CITY OF ALBUQUERQUE

November 16, 2015

**RE: Volcano Cliffs Subdivision Lot 6 Block 7 Unit 18
6512 Pato Rd. NW
Grading and Drainage Plan
Engineers Stamp Date 11/9/15 (D10D003L6)**

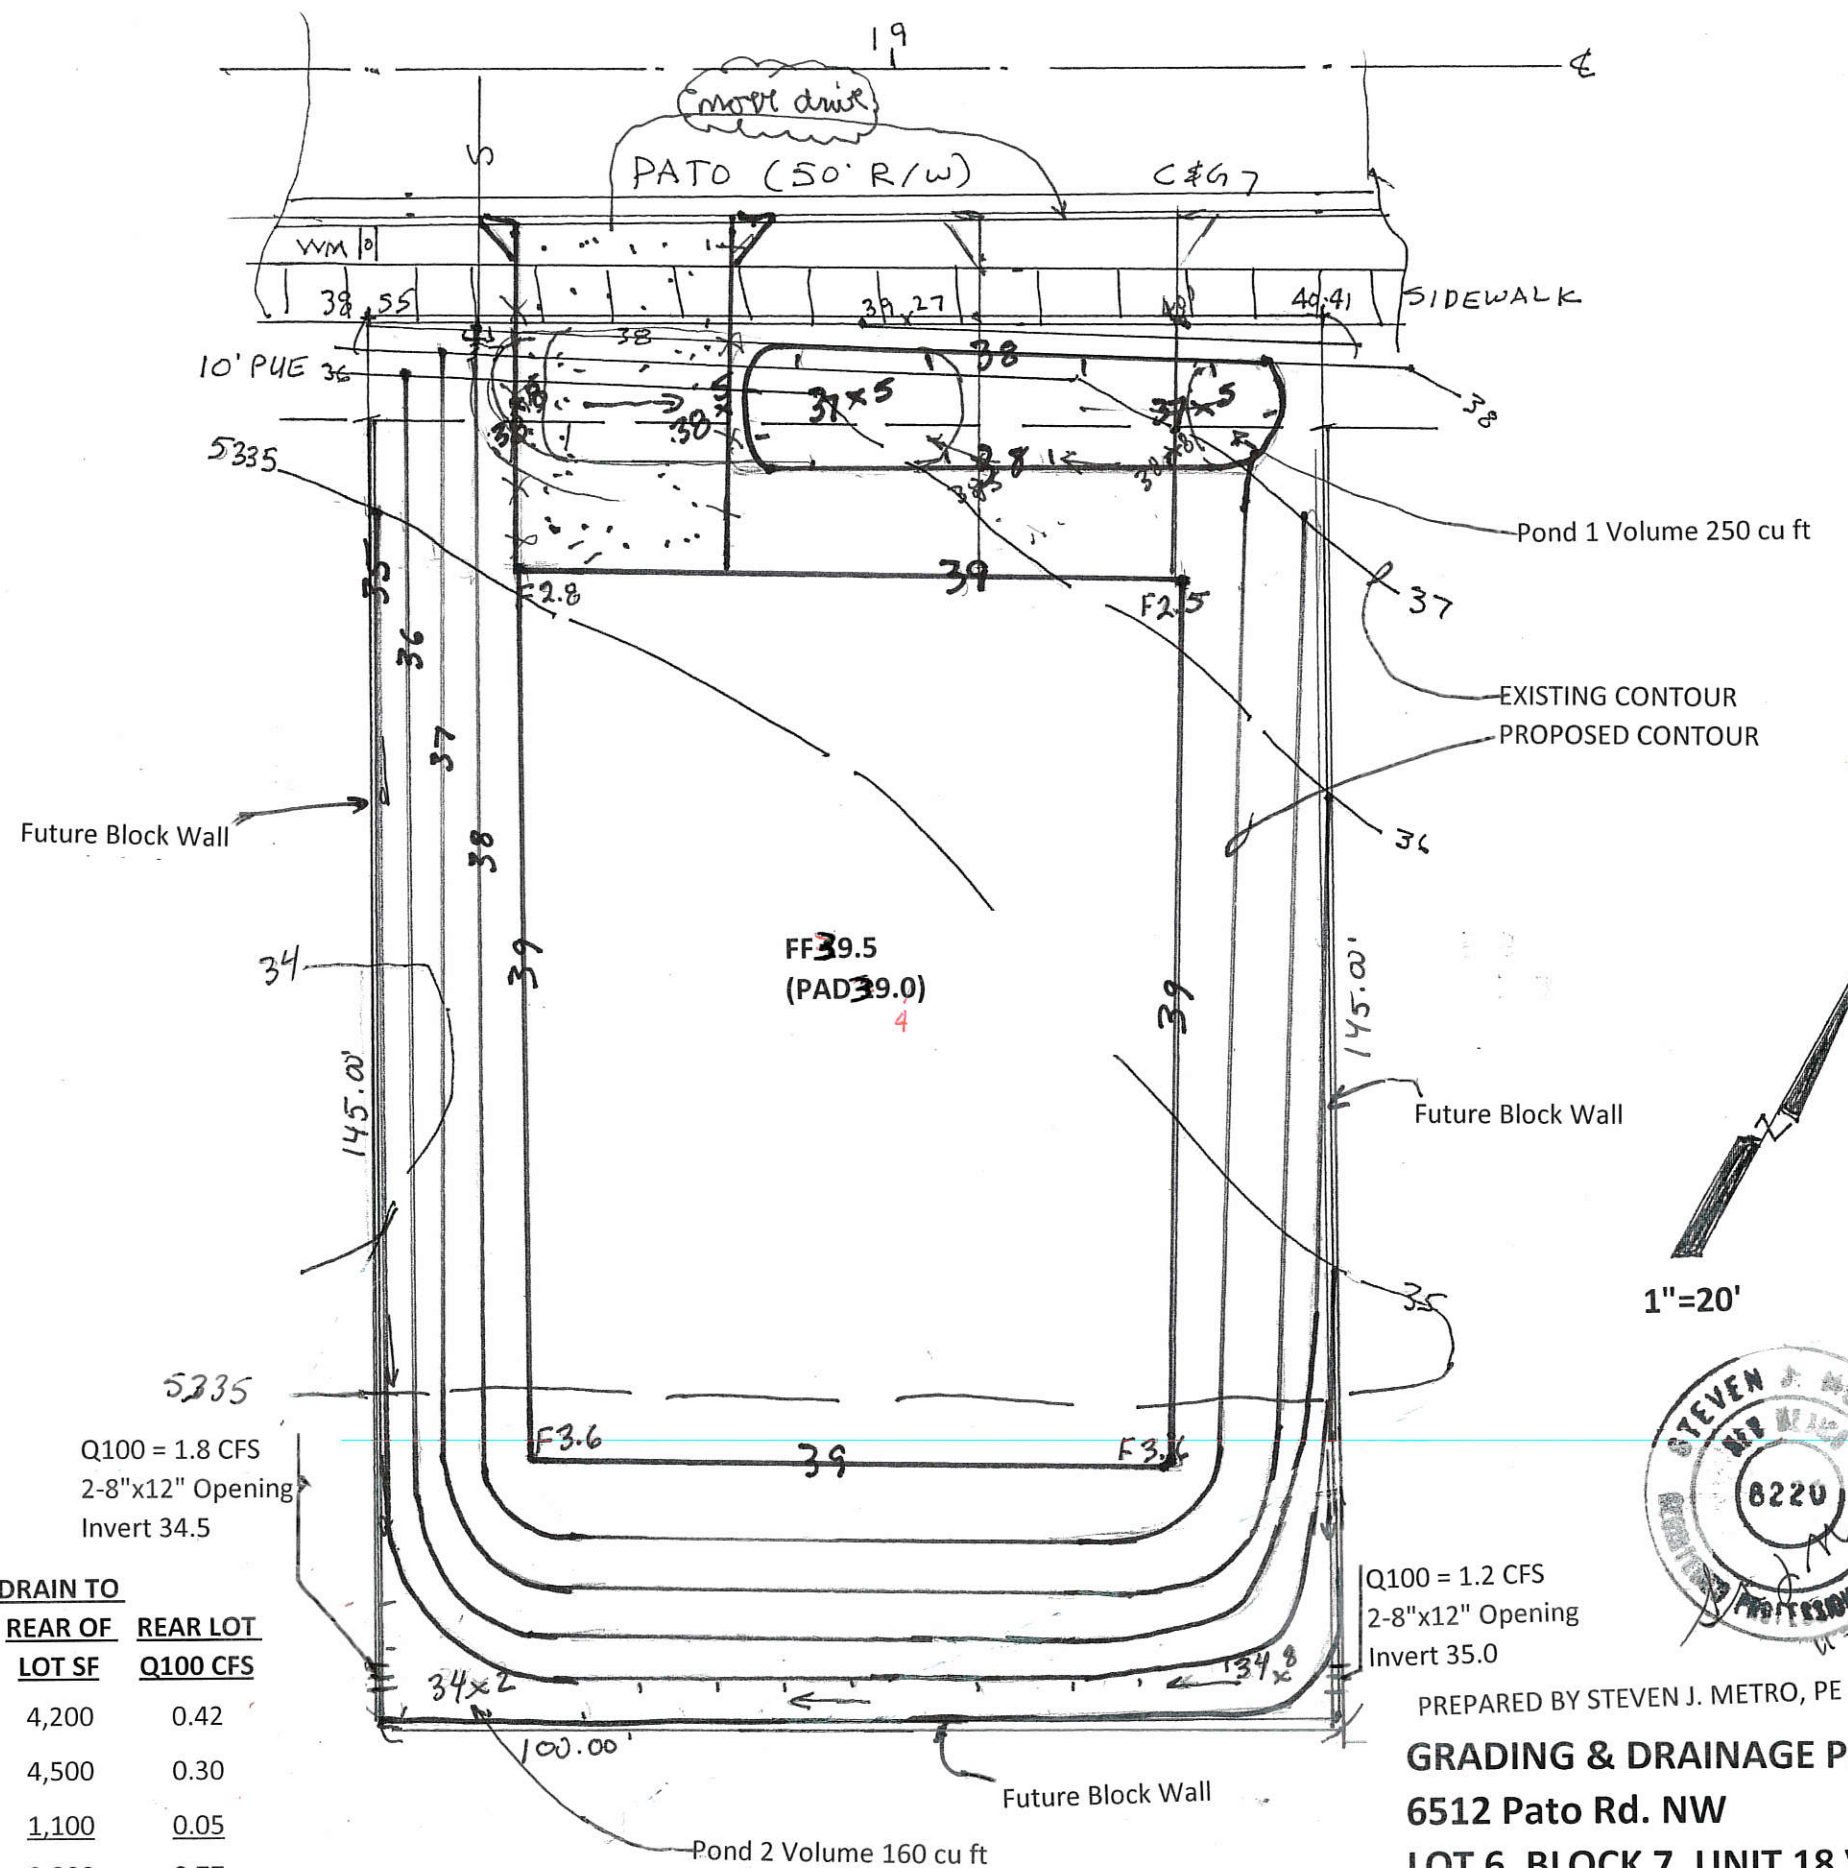
Based upon the information provided in your submittal received 11/9/15, this plan is approved for Grading Permit and Building Permit.

Please attach a copy of this approved plan to the construction sets in the permitting process prior to sign-off by Hydrology.

Prior to Certificate of Occupancy release, Engineer Certification per the DPM checklist will be required.
